Scientific Notebook 353

Project: 20-01405-041 Private Fuel Storage Facility

**Title:** Evaluation of PFS Earthquake Analyses for SER on PFSF License Application (SAR)

**Purpose:** To document comparison of Private Fuel Storage Facility (PFS) probabilistic seismic hazard results (PSHA) to other PSHA results for the western United States.

Table of PGA values derived from Frankel et al (1997) curve.

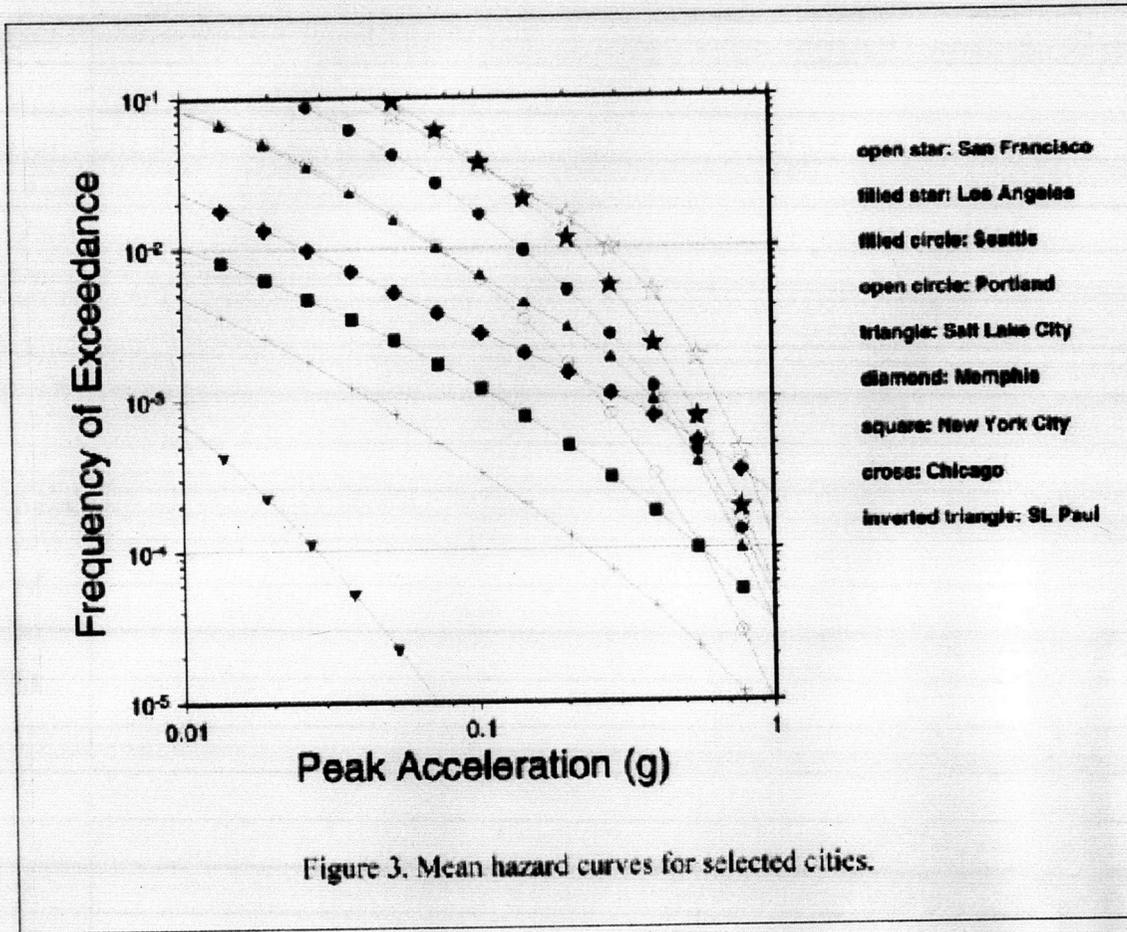
The following figure (figure 3) is from that paper. From the figure I digitized values for the Salt Lake City Hazard curve, and converted them to cm/s/s  $1 g = 9.8 m/s/s = 980 cm/s/s$ .

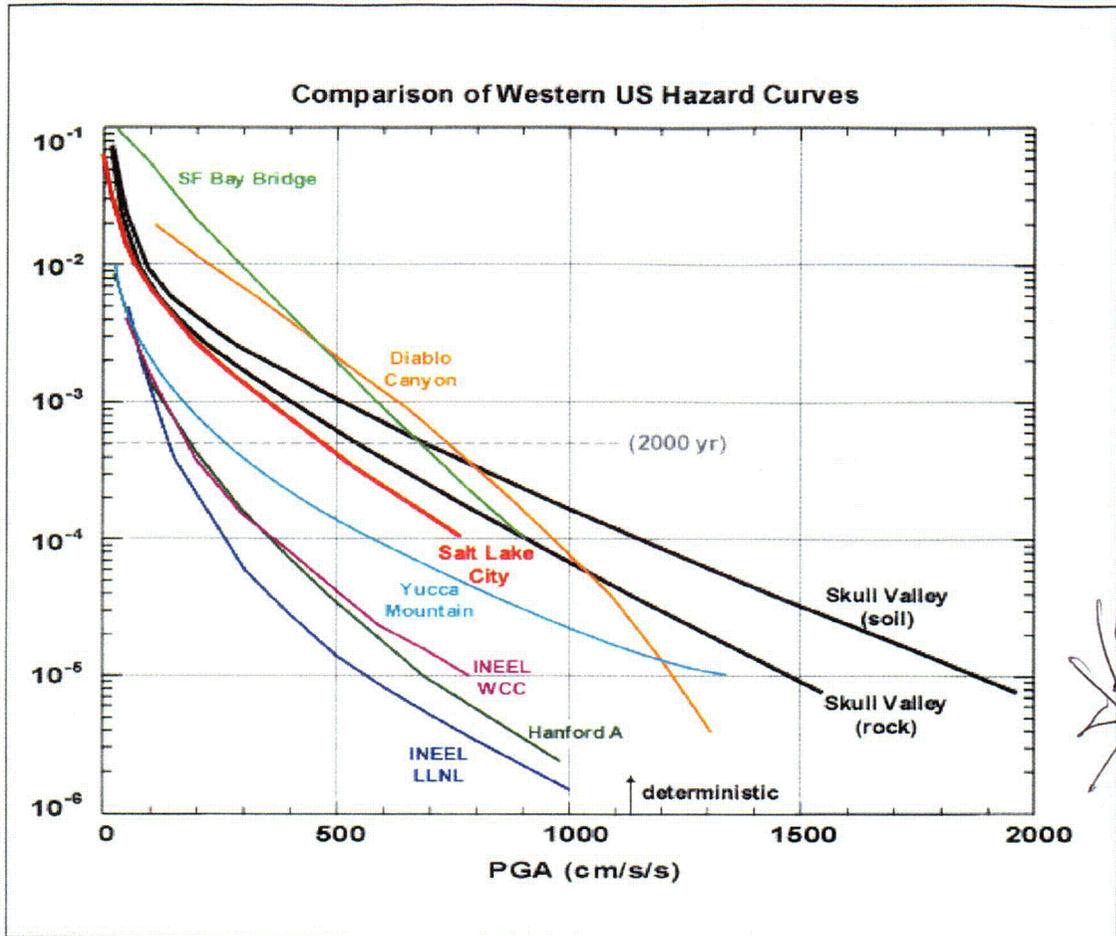
3. I then plotted all the data (using Kaleida Graph, version 3.09) to produce the following graph.

The results show the conservative nature of the applicant's source characterization and PSHA results presented in the SAR. This conservatism is evident when the results are compared to PSHA results for other sites in Utah, especially those in and around Salt Lake City. This a comparison shows that the seismic hazard in Skull Valley was calculated by the applicant to be higher than seismic hazard estimates that have been performed for sites at, or near, Salt Lake City, despite the fact that fault sources near Salt Lake City are larger and more active than fault sources near the PFS site. For example, the results of the applicant's PSHA for Skull Valley (Geomatrix Consultants, Inc., 2001a) suggest that it is 1.5 times more likely that a ground motion of 0.5g horizontal peak ground acceleration or greater will be exceeded at the PFS site (assuming hard rock site conditions), than at Salt Lake City, based on the USGS National Earthquake Hazard Reduction Program (Frankel et al., 1997).

Similarly, the 2000-yr horizontal peak ground acceleration for Skull Valley (soil hazard) as estimated by the applicant, is higher than the 2500-yr ground motions for the nine sites along the Wasatch Front that were evaluated as part of the Utah Department of Transportation I-15 Reconstruction Project (Dames & Moore, Inc., 1996). The ground motions estimated by the applicant in Skull Valley are higher than those for the I-15 corridor, despite the close proximity of Salt Lake City to the Wasatch fault, which has a slip rate nearly ten times larger than the Stansbury or East Faults (cf., Martinez et al., 1998; Geomatrix Consultants, Inc., 1999a ) and is capable of producing significantly larger magnitude earthquakes than the faults near the PFS Facility site in Skull Valley (cf., Machette et al., 1991; Geomatrix Consultants, Inc., 1999a).

Slip Tendency Plot

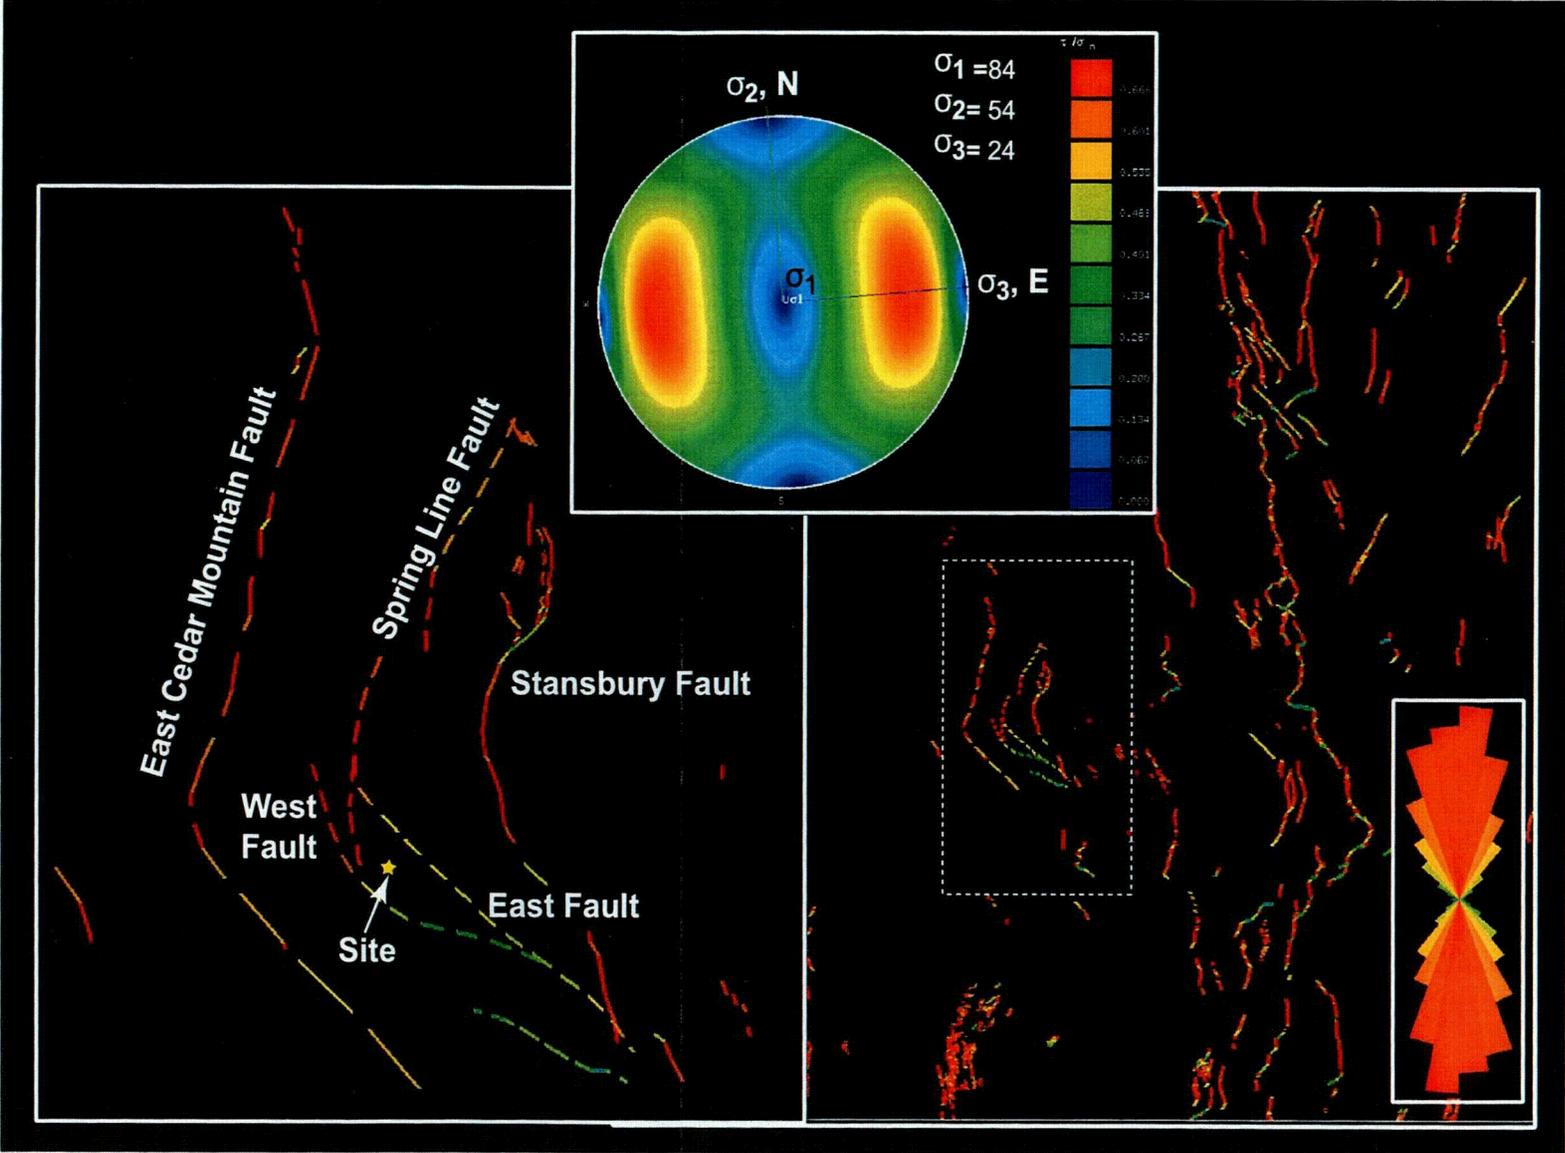
The following two pages are figures from 3DStress™ that summarize the slip tendency results. The first figure is an electronic snapshot of the screen showing the results of the analysis. The second figure is a summary shot showing a close-up of Skull Valley along site the central Utah regional map.

The slip tendency analysis shows that segments of the East fault and the East Cedar Mountain fault nearest the PFS site have relatively low slip tendency values compared to segments farther north in Skull Valley. As discussed in the following sections on site-to-source distances and maximum magnitudes, these results indicate that the seismic source characterization of the PSHA study conducted by Geomatrix Consultants, Inc. (1999a, and 2001a) is conservative. Three areas of conservatism are the distribution of site-to-source distance, maximum magnitude earthquakes, and potential of the West fault as a seismogenic source (discussed in Stamatakos et al., 1999).

Results of the slip tendency analysis indicate that fault segments with approximately North-South strikes (azimuth = 175°) are optimally oriented for future fault slip. Faults with north northeast-south southwest strikes have high slip tendency values. In contrast, fault segments with northwest-southeast strikes, such as the East fault near the PFS Facility site and the southern segments of the East Cedar Mountain fault also near the PFS Facility site, have relatively low slip tendency values. Therefore, these fault segments are less likely to slip in the future than fault segments further from the site. Fault rupture close to the site greatly influence the seismic hazard. The closer the earthquake is to the site, the larger the resulting ground motions compared to an equal magnitude earthquake on a fault segment farther away from the site.

The slip tendency results suggest that Geomatrix Consultants, Inc. (1999a) may have overestimated the maximum magnitude of the East and East Cedar Mountain faults near the PSFS site. In the SAR, the applicant first developed conceptual models of the physical dimensions of fault rupture—either rupture area or trace length of surface fault rupture—based on the geologic record (Geomatrix Consultants, Inc., 1999a). Second, the applicant developed distributions of maximum magnitudes for each active fault using empirical scaling relationships developed from the magnitudes and associated rupture dimensions of historical earthquakes (e.g., Wells and Coppersmith, 1994). In developing the fault segment models, the applicant conservatively assumed that the entire mapped length of the surface trace length represents active fault segments. Thus, these maximum fault dimensions produce conservative estimates of maximum magnitude.
